| Model: Schmidt3 | | | Dat | te: 31-Oct-99 | | No.: RH547001 | |
| Subject: New Functions in the Schmidt3 G4 Unit | | | | Prepared by: K. Misugi | | | J |

This RTB informs the changes made to the G4 (SiG4) unit software and corrections to the Schmidt3 ISDN Unit service manual.

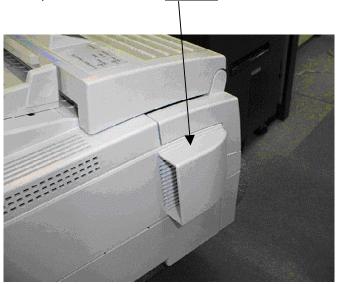
- The running time of the fan is longer than the original time using the old ROM.
- We cannot change the fan control in Schmidt 3.
- 2) Silencer

We will provide a special part called a "Silencer" which can be set at the air exit near the fan by the customer. (See below)

This will reduce the noise from the fan.

The part number of the Silencer is H5459500. This part will be available soon at SPC.
